**TRAFFIC CIRCULATION LAYOUT APPROVED**

## **TRAFFIC CERTIFICATION**

**Re: Tract 1 & 3 East Central Gateway Plaza, 10201 Central Ave NE**  
**60-Day Temporary Certificate of Occupancy- Transportation Development**  
Architect's Stamp dated 05-05-14 (K20-D061)  
Certification dated 12-09-14

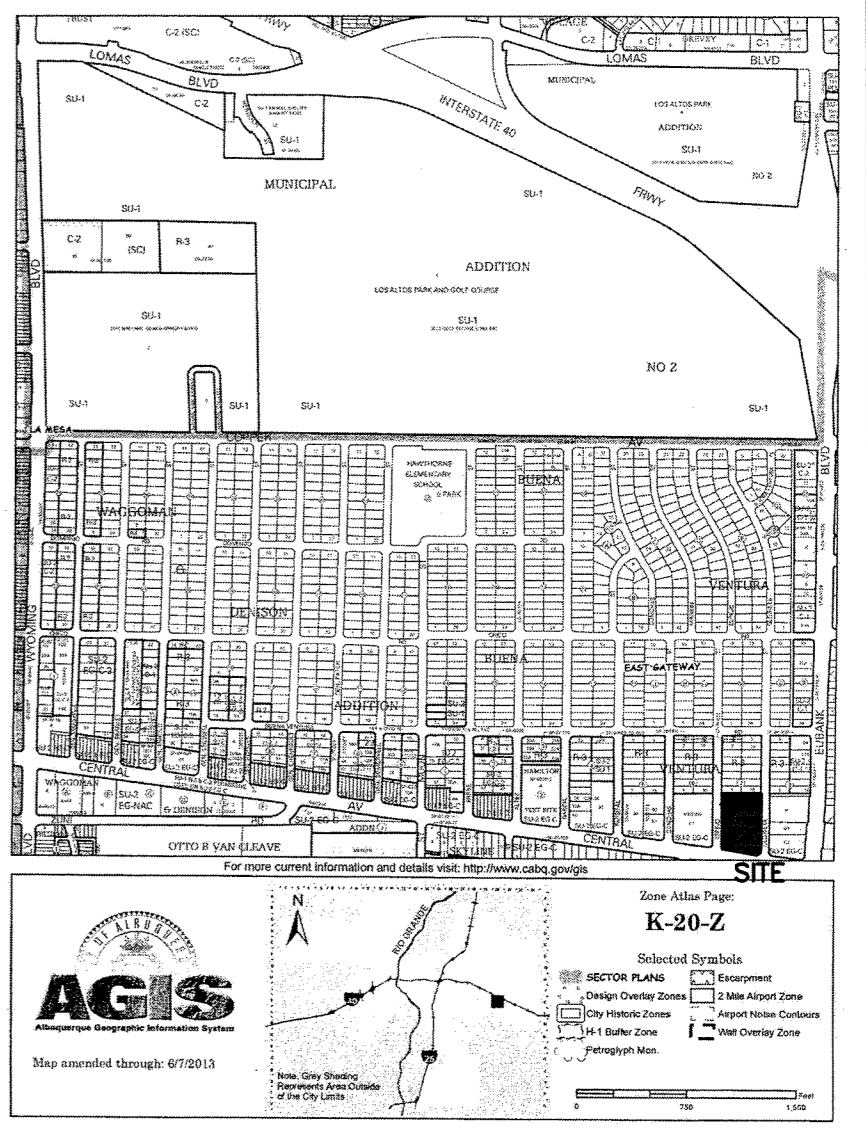
- The corner curb ramp at Central Ave and Espejo St NE needs to be removed and replaced per the City of Albuquerque Standard Specifications drawing 2426 to comply with ADA access.
- All wheel chair ramps located within the public right of way must have truncated domes. The wheel chair ramp on the corner of Central Ave and Espejo St NE is missing the truncated domes.
